Our Ref: K-2578-IRR-001
Your Ref: OP3043/2019
Date: 31 May 2019

Re: Information Request – Operational Works – 12 Crawford Street, Mossman

Response

JOB No: **K-2578**
 SHEET: **SK5 | A**
 SCALE: 1:500 (@ A1)

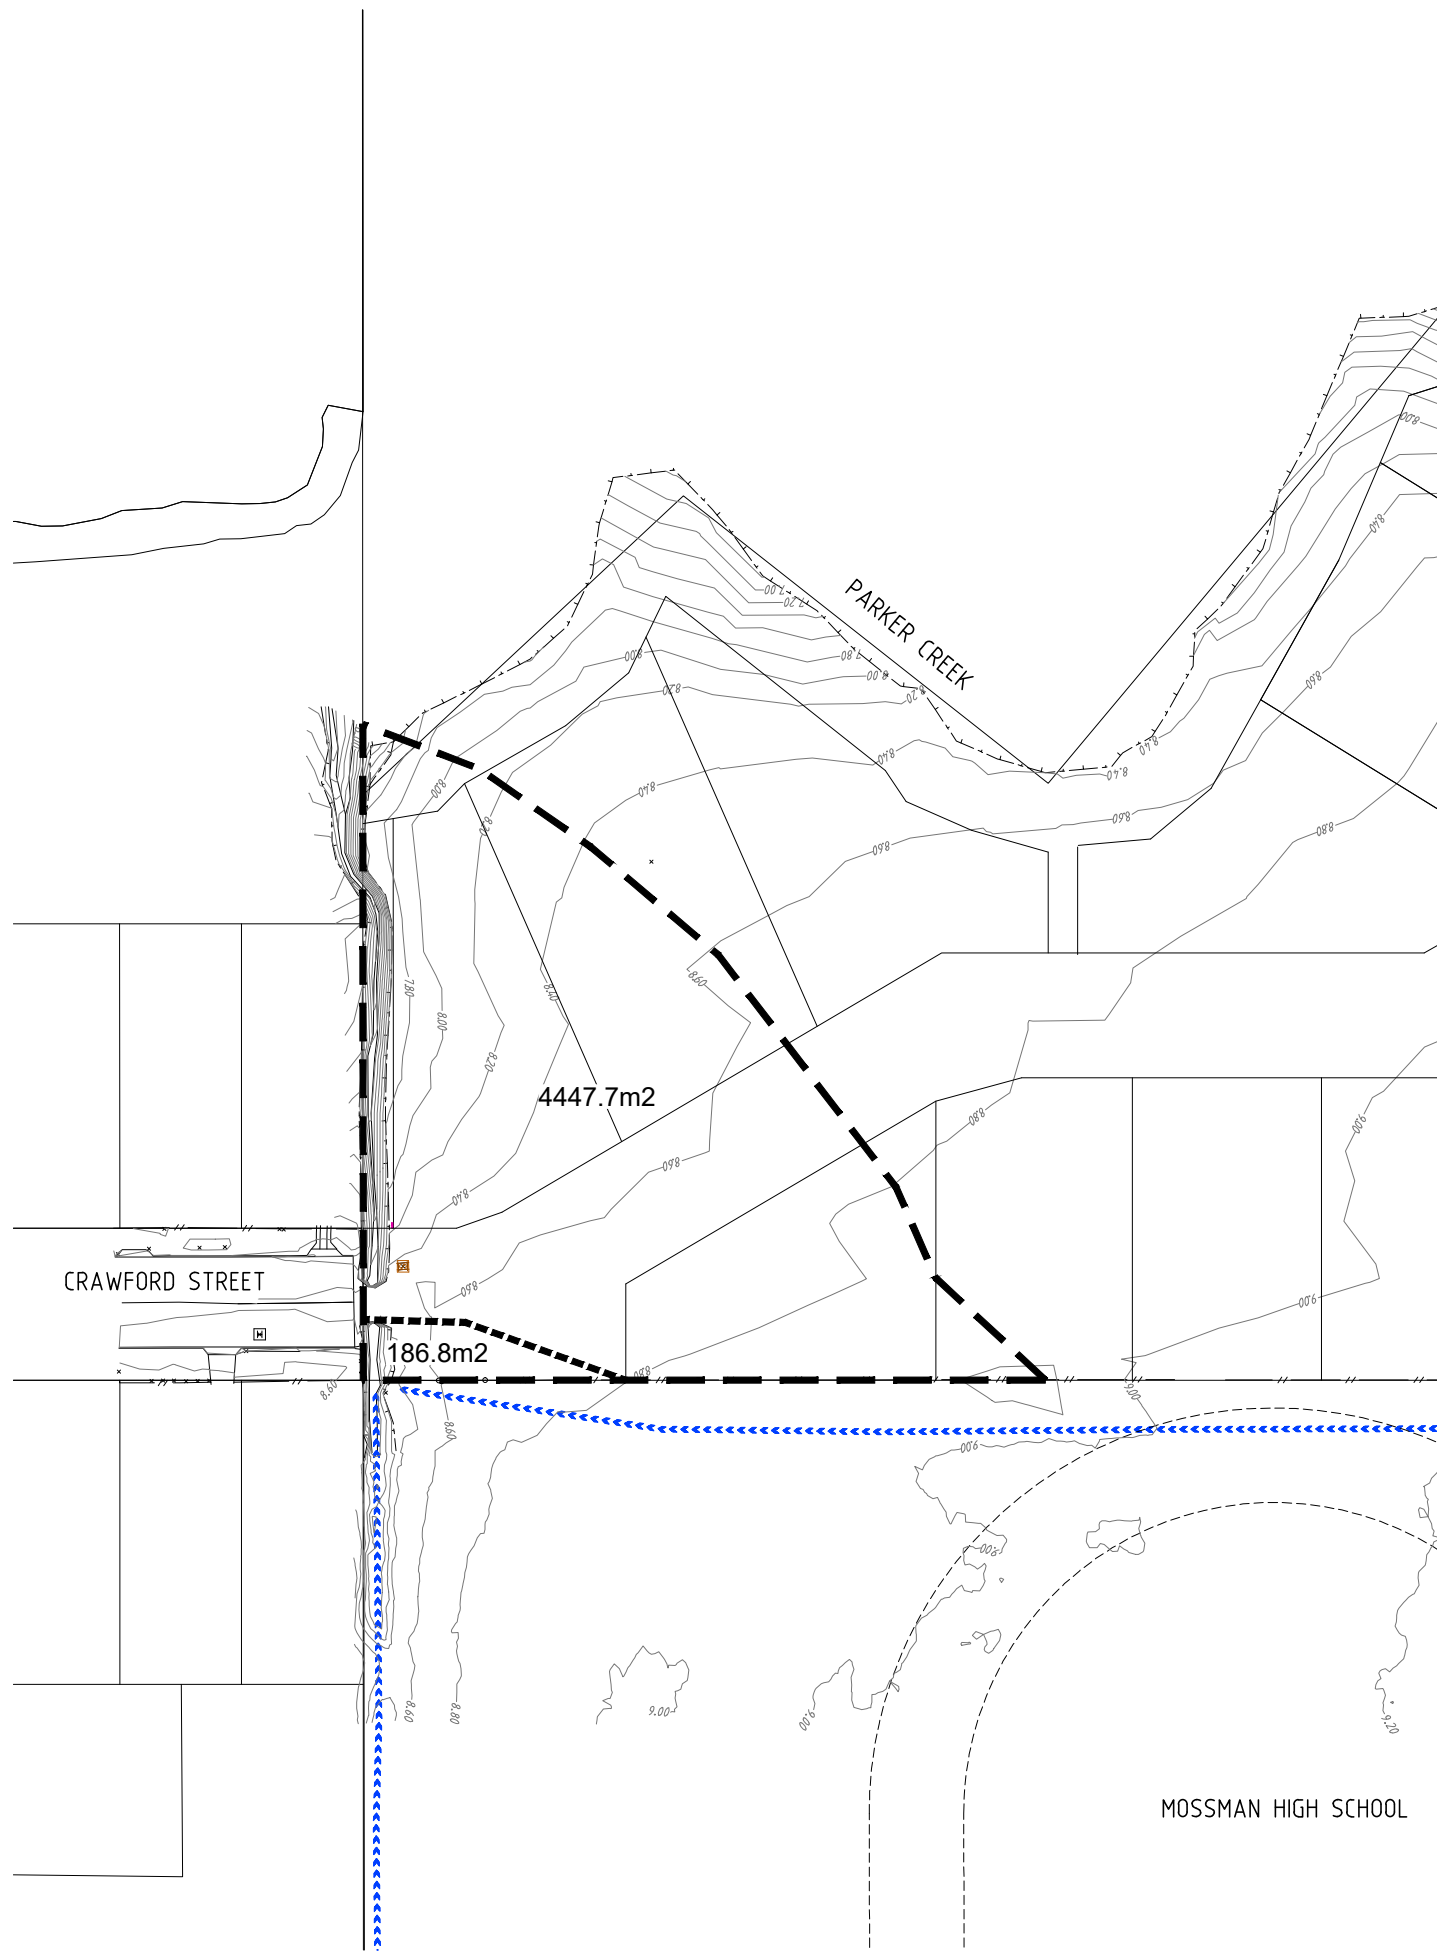
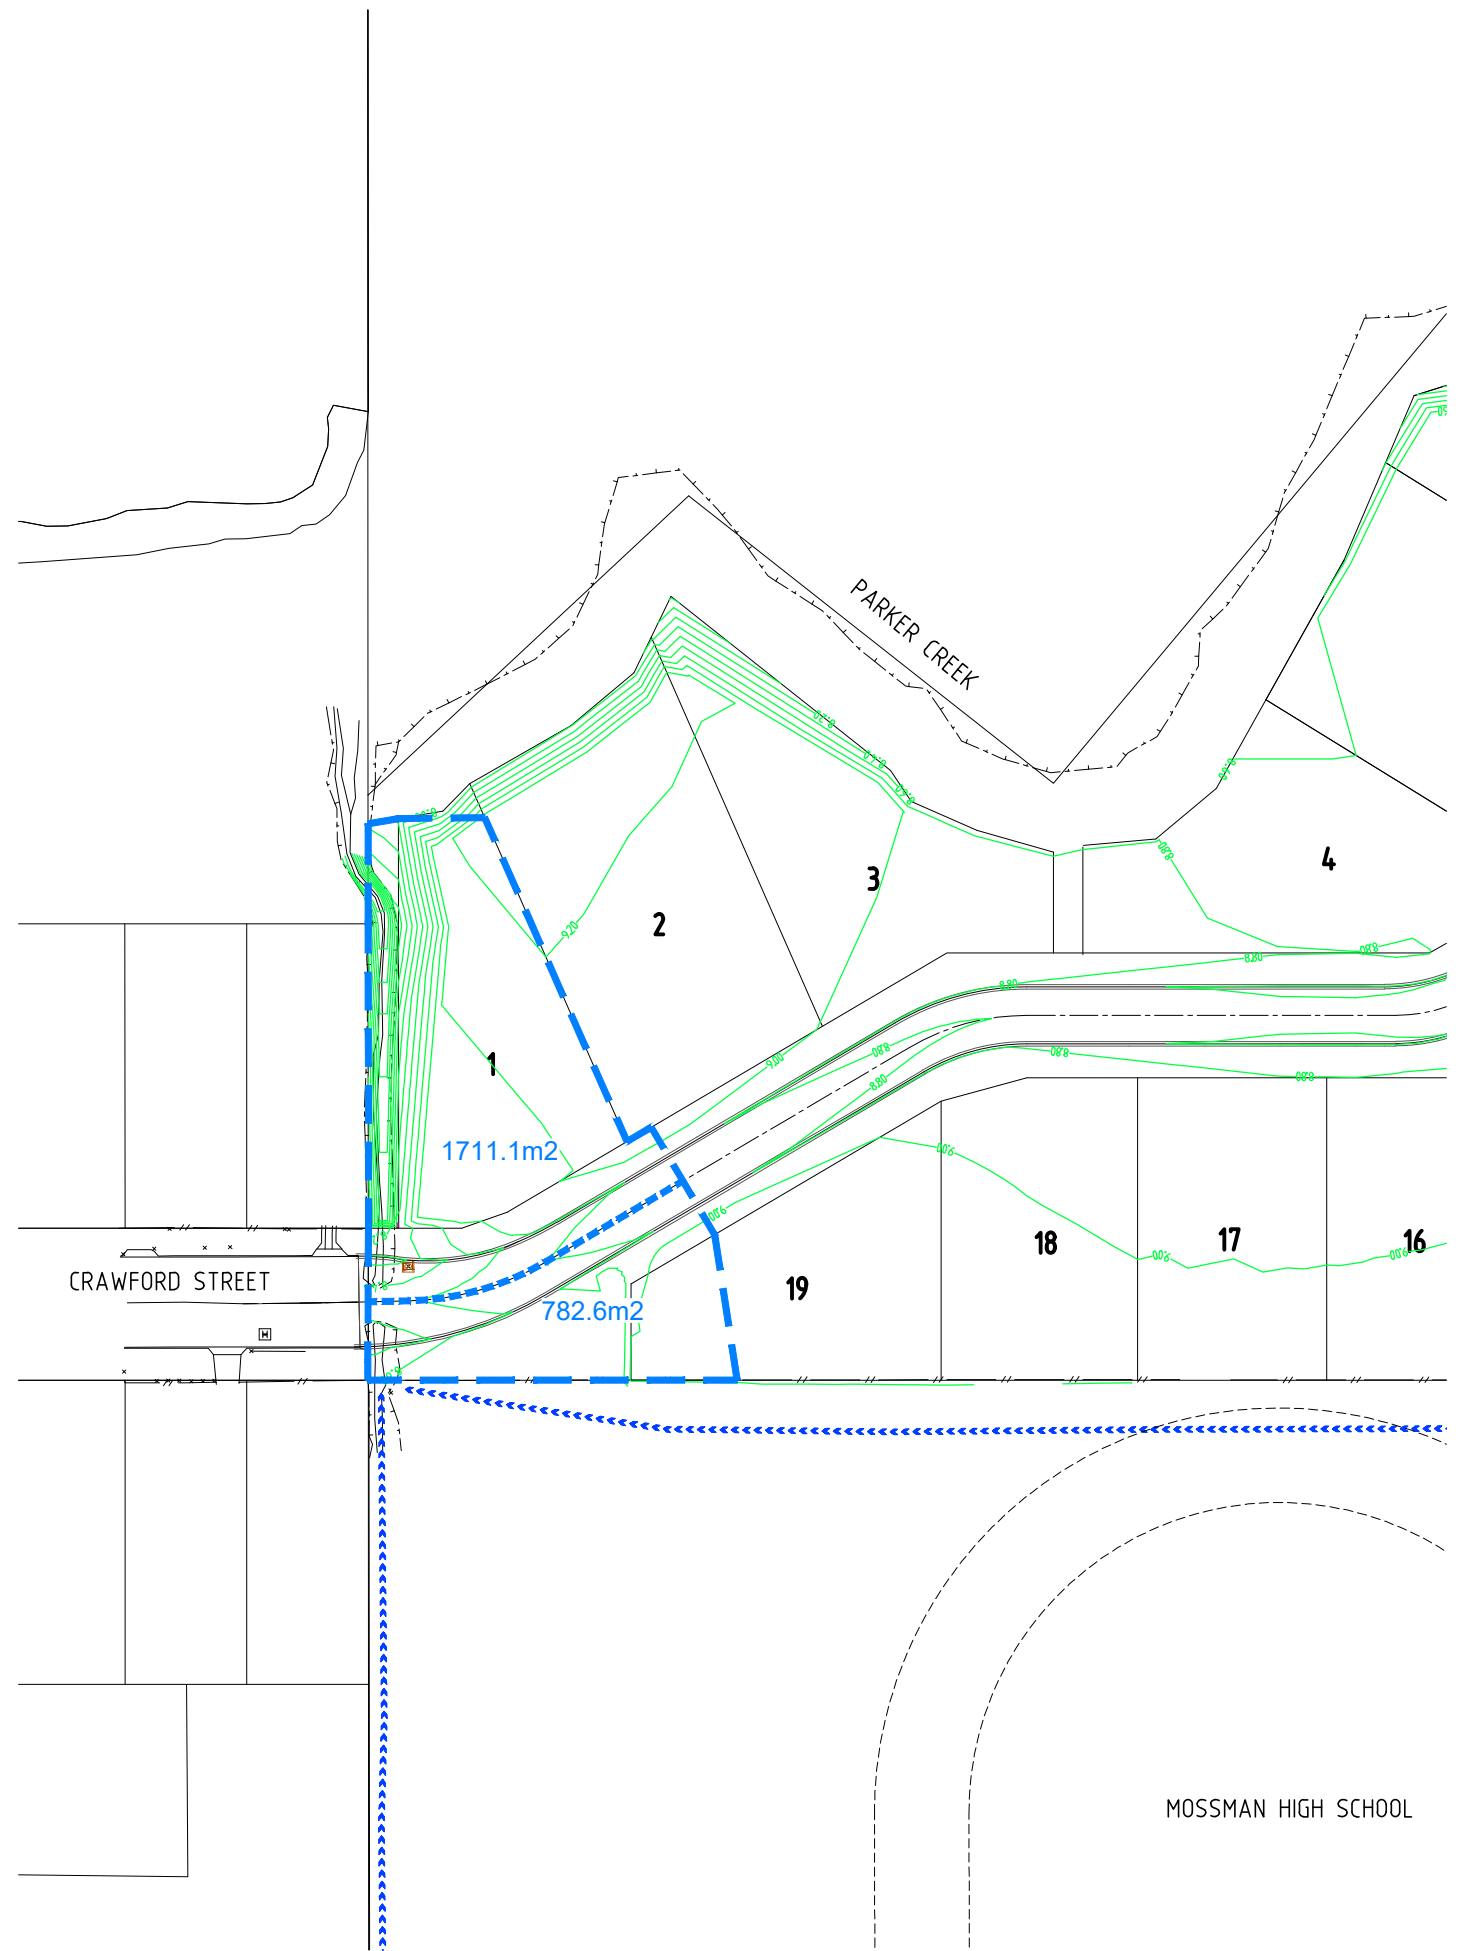
Provide the assessment of the capacity and impacts of downstream streets (Crawford, Ingles, Williams). Council officers note that the lots on the eastern side of Crawford appear to be situated below the road.

Stormwater flow will not travel northwards along Crawford Street as stated by the reviewer and as such the flow down existing Crawford Street has not been increased. . On that basis there is no requirement to make *an assessment of the potential impacts of this changed stormwater scenario* or provide an *assessment of the capacity and impacts of downstream streets (Crawford, Ingles, Williams)*.

Pre and Post development catchments contributing to the join with the existing Crawford Street construction are detailed on attached KFB drawing K-2578 Sheet SK5A and shows that:
